REPORT TO PLANNING COMMISSION

CITY OF COLLINSVILLE

APPLICATION NUMBER(S)	RZ 24-06 Rezoning
APPLICATION NAME:	Collinsville Area Vocational Center (CAVC)
APPLICANT NAME:	FGM Architects, Inc. 475 Regency Park #325 O'Fallon, IL 62269
PROPERTY OWNER NAME(S):	Collinsville CUSD10 201 W Clay Street Collinsville, IL 62234
APPLICANT'S REQUEST:	A request by FGM Architects, Inc., on behalf of property owner, CUSD10, to rezone property located at 1050 Caseyville Road, from "R-1" Single Family to "P-R-1" Planned Single Family to permit design deviations from the municipal code for the development of the new CAVC facility.
SITE ADDRESS(S):	1050 Caseyville Road
PARCEL ID NUMBER(S)	03-05.0-300-018 & 03-05.0-300-026
EXISTING ZONING DISTRICT(S):	"R-1" Single Family Residential
PROPOSED ZONING DISTRICT(S):	"P-R-1" Planned Single Family Residential
TOTAL SITE AREA:	20.93 acres
COMMISSION MEETING DATE:	January 9th, 2025
CASE MANAGER:	Caitlin Rice, AICP, Senior Planner
RECOMMENDATION:	Approval with Conditions

Eastern façade elevation (fronting Caseyville Rd).

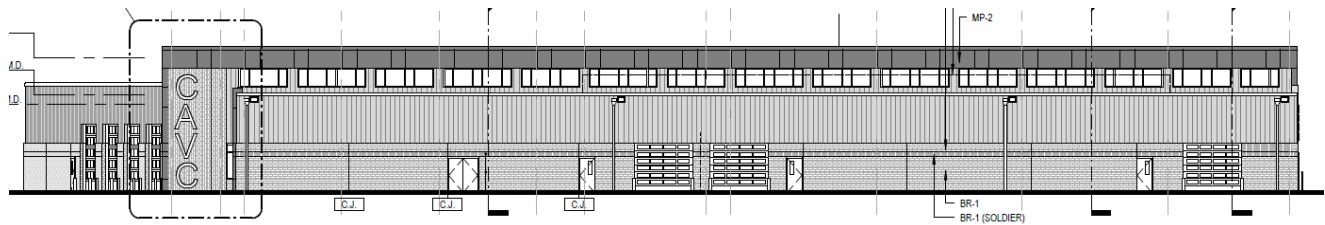
1. VARIANCE #1: Section 17.060.260. Façade Design:

- a. Windows: All buildings other than distribution/industrial require no less than 40% of façade that front a street between 2 and 10 feet.

⇒ *The eastern façade is street facing, but not primary entrance. This area of the building is classroom & workshop space. Clerestory windows provided instead.*

Overview of Landscape Plan

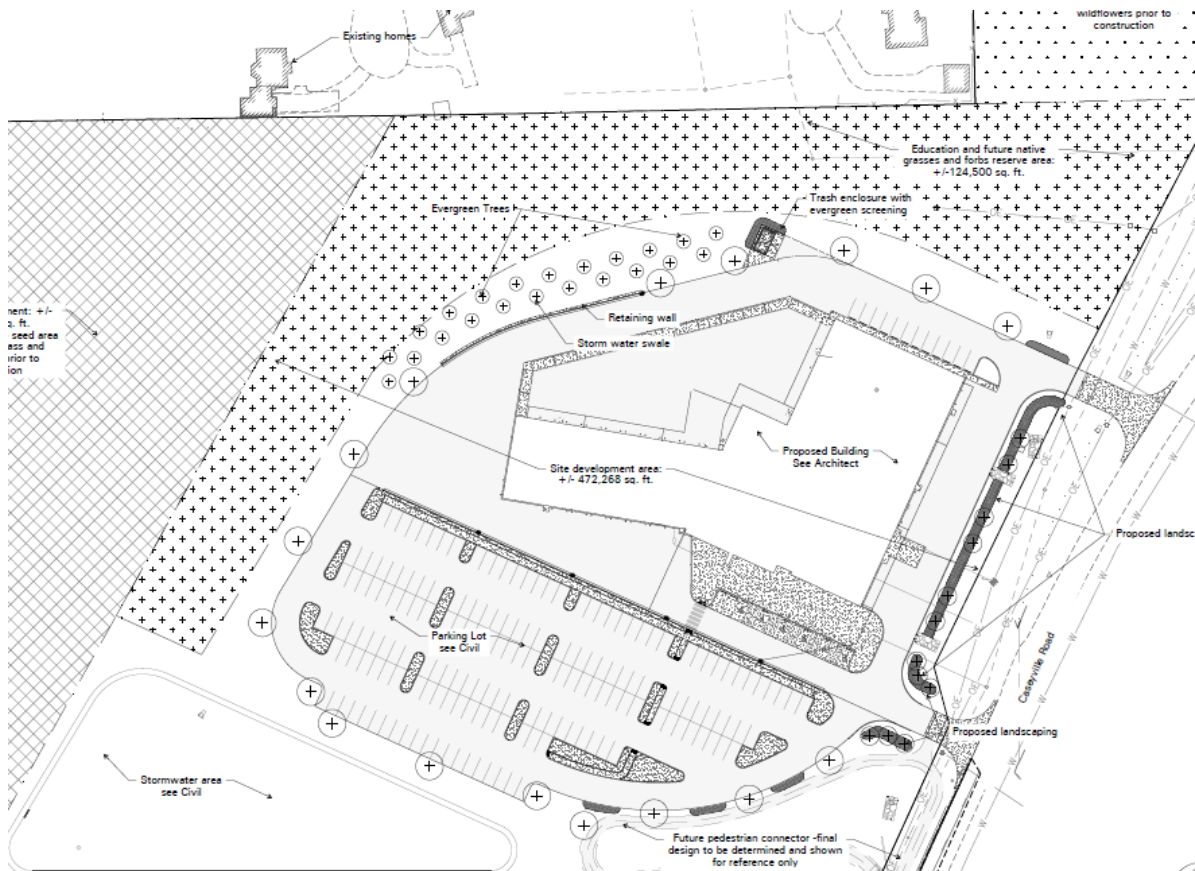
- a. Phasing: Landscaping proposed to be installed in stages. Initial portion by the contractor and the remainder by students.
- b. Irrigation: all proposed materials are native and drought tolerant. Hand watering is proposed instead of traditional inground irrigation system.

- c. Parking Lot Landscaping: Requesting that required trees in parking lot islands is waived, and instead install trees along perimeter of lot and in larger islands.

Eastern façade elevation (fronting Caseyville Rd).

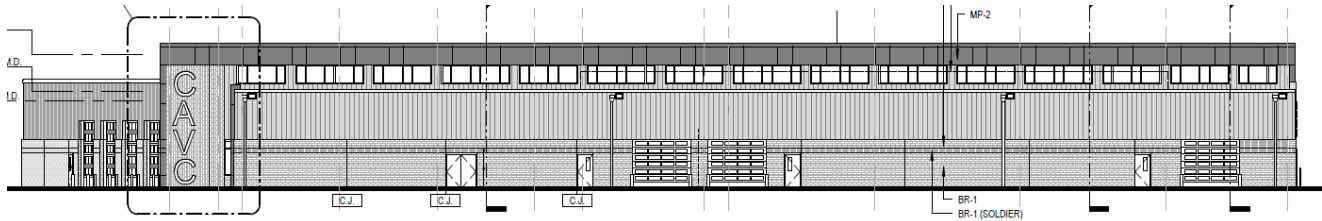
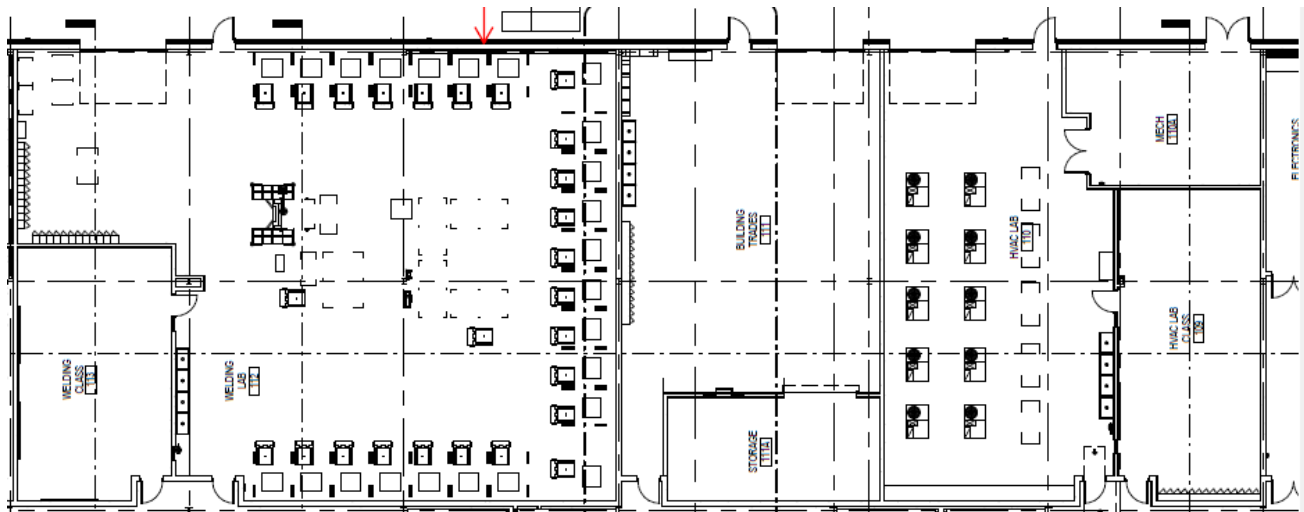
1. VARIANCE #1: Section 17.060.260. Façade Design:

- a. Windows: All buildings other than distribution/industrial require no less than 40% of façade that front a street between 2 and 10 feet.

⇒ Eastern façade is street facing, but not primary entrance. This area of the building is classroom & workshop space with bay doors. Clerestory windows provided instead.

Below is the building floor plan for the eastern section of the building. This section is split between several work spaces including a welding lab, building trades, HVAC lab, and electronics lab.

The intent of this section is to ensure health and quality of life in commercial development as well as encourage pedestrian scale development by requiring window standards. The proposed development is primarily educational workshop space, with industrial needs such as automotive workspace and bay doors. Staff's interpretation is that although the use of the building is education, the type of education and design of the building complements the standards required for traditional industrial buildings. These developments in Collinsville focus windows in office space, and utilize clerestory windows in warehouses or workspace, meeting the intent of the ordinance. Staff recommends approval of this deviation request.

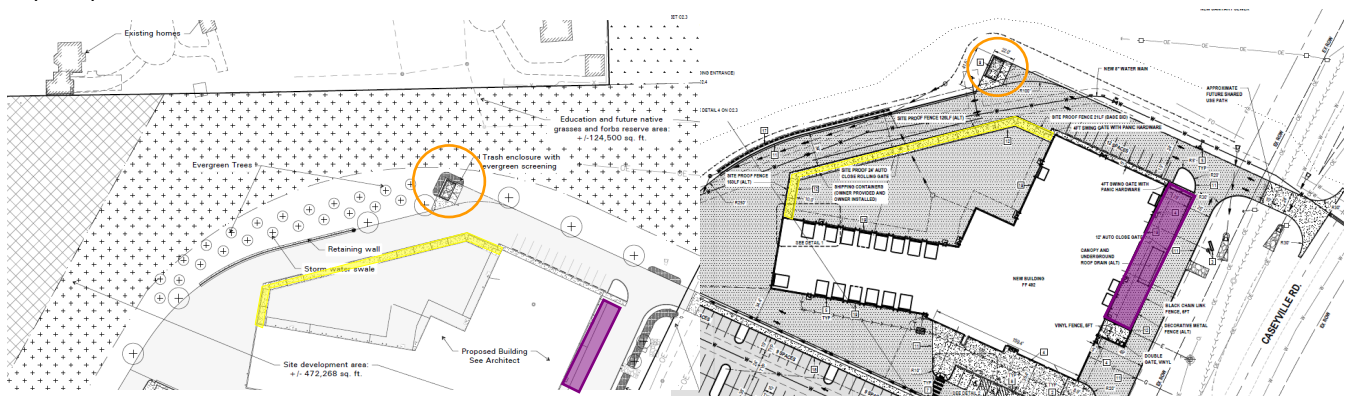
- b. **Rear Automotive Yard: Proposing shipping containers to act as fence/screen as well as functional element for storage in the outdoor classroom. Alternate proposal of sight proof fence to screen containers.**

Yellow Area: Rear Automotive Yard Shipping Container Screen. Alternative is a sight proof fence to screen containers.

Orange Area: Dumpster Enclosure (chain link & evergreens)

Purple Area: Eastern Workspace: Proposed black coated chain link, alternative decorative metal fence

The enclosure is setback behind the building. The visible part of the enclosure from Caseyville Road is the gates, which will be 100% opaque. The combination of coated chain-link and evergreen planting screen meets the minimum 75% opaque requirement for enclosures not visible from the right-of-way. Staff finds that the proposed dumpster enclosure meets the intent of the Zoning Ordinance and recommends approval of this request.

Staff finds that the use of shipping containers in the rear of CAVC for storage of the automotive yard is permissible if screened as required by code, as such is the requirement for all other areas of the City. Staff recommends a sight proof fence or a minimum of 75% coverage by evergreen landscaping or similar screening method.

Eastern Workspace: Proposed black coated chain link, alternative decorative metal fence

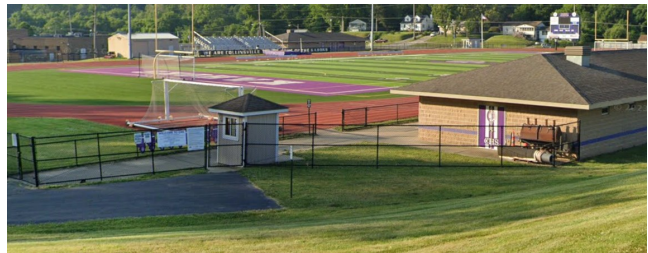
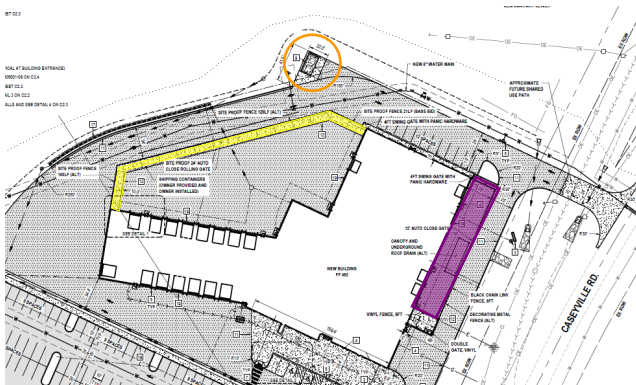
- c. Eastern Outdoor Workspace: Proposing 6' black chain link fence adjacent to Caseyville Road. Alternate proposal of decorative metal fence.

The applicant is requesting a deviation for black vinyl coated chain-link fencing in the front yard for the following reasons (Exhibit A):

1. A variance is requested to use black chain link fencing in the front yard. This choice is motivated by cost considerations and the desire for visual cohesion, as it mirrors the fencing found across the street. The fence is needed on the side of the building facing Caseyville Road to provide an enclosed, secure area for outdoor learning for the building trades class. By opting for this style of fencing, we maintain a consistent appearance within the neighborhood. A black chain-link fence will match all other fencing at Collinsville High School Campus.

The proposed chain-link fence will be setback approximately 56' feet from the right-of-way of Caseyville Road. In the existing code, coated chain-link fencing is permitted by right in the secondary front yards, side yards, and rear yards on commercial and residential properties. Staff finds that due to the unique layout and design of the facility, proposed distance from Caseyville Road, and the consistency of the fencing to the high school, the proposed coated chain-link fencing will not negatively impact the surrounding area. Therefore, staff recommends favorable consideration of this deviation request.

Overview of Landscape Plan

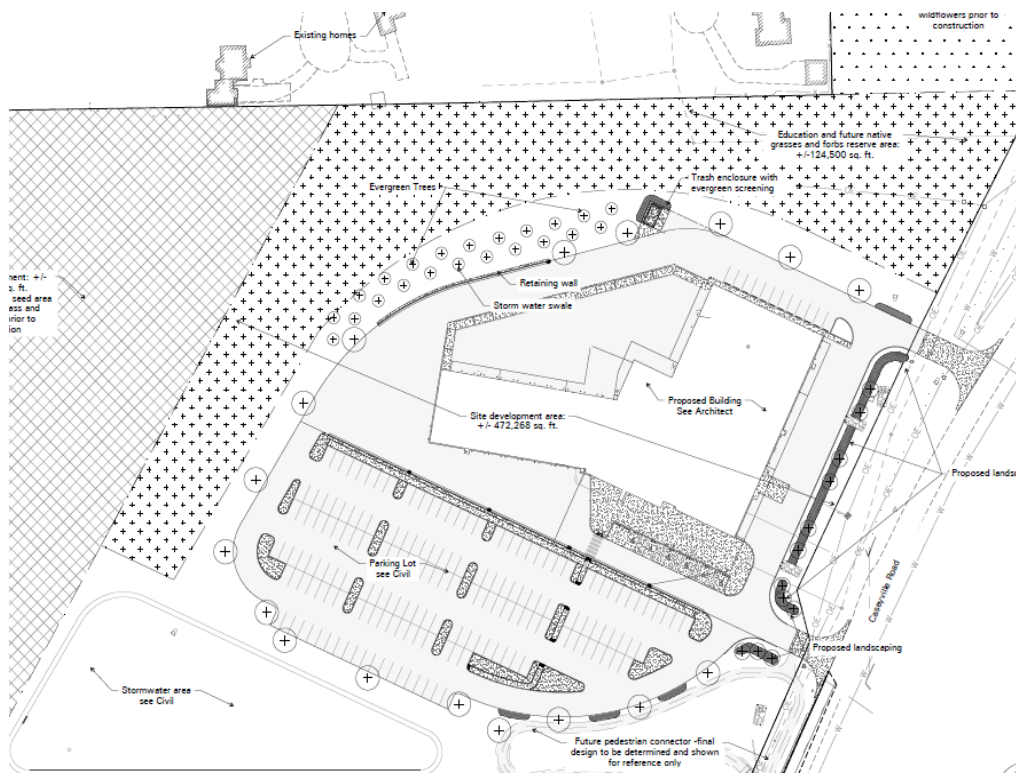
- c. **Parking Lot Landscaping:** Requesting that required trees in parking lot islands is waived, and instead install trees along perimeter of lot and in larger islands.

We request a variance to the tree requirements for interior islands within the parking lot and instead propose to install trees along the perimeter and in larger islands. Trees planted in small interior islands often struggle to thrive, leading to maintenance issues that do not support our educational goals. By concentrating our tree planting efforts in more suitable areas, we can ensure their health and longevity while creating a more aesthetically pleasing environment.

Staff recognizes that trees planted in parking lot islands can have high rates of failure. Trees in landscaped islands need to be a species that can tolerate salt, sun, heat, soil compaction and drought. Historically, islands in parking lots have not been designed to properly support tree life. Islands can be too small and not have enough soil volume to support the tree. While staff recognizes this, there are methods to ensure a more successful tree, such as selecting a species that can withstand these conditions, and properly designing the landscaped island to support the tree, even if it exceeds the minimum standards the City requires.

Tree islands are required in the code to help provide shade to parking lots as well as decrease stormwater runoff, increasing quality of life in new developments. Acceptance of this deviation would result in a precedent set for all future new development. Therefore, staff does not recommend approval of this deviation request.
